**SALEM GENERATING STATION UNIT 2  
FACILITY OPERATING LICENSE NO. DPR-75  
DOCKET NOS. 50-311  
CHANGE TO TECHNICAL SPECIFICATIONS (TS)  
DEFERRAL OF SURVEILLANCE REQUIREMENTS**

**SALEM GENERATING STATION UNIT NO. 2  
CHANGE TO TECHNICAL SPECIFICATIONS  
DEFERRAL OF SURVEILLANCE REQUIREMENTS  
TECHNICAL SPECIFICATION PAGES WITH PROPOSED CHANGES**

LR-N980452  
LCR S97-30

3/4 3.2 ENGINEERED SAFETY FEATURE ACTUATION SYSTEM INSTRUMENTATION

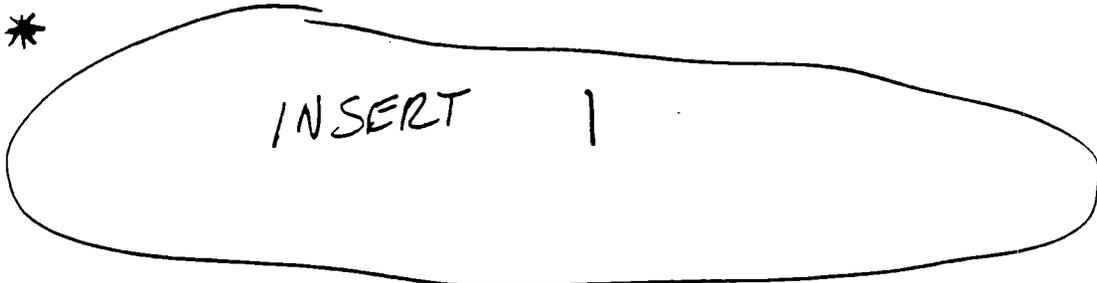
4.3.2.1.3 The ENGINEERED SAFETY FEATURES RESPONSE TIME of each ESFAS function shall be demonstrated to be within the limit at least once per 18 months. ~~Each~~ test shall include at least one logic train such that both logic trains are tested at least once per 36 months and one channel per function such that all channels are tested at least once per N times 18 months where N is the total number of redundant channels in a specific ESFAS function as shown in the "Total No. of Channels" Column of Table 3.3-3. The provisions of Specification 4.0.4 are not applicable to MSIV closure time testing. The provisions of Specification 4.0.4 are not applicable to the turbine driven auxiliary feedwater pump provided the surveillance is performed within 24 hours after the secondary steam generator pressure is greater than 680 psig. \*

INSERT 1

\* A one time exemption to this surveillance requirement is granted during fuel cycle ten allowing Unit 2 operation to continue to the tenth refueling outage (2R10). The surveillance is to be completed at the appropriate time during the 2R10 outage, prior to the unit returning to Mode 4 upon outage completion.
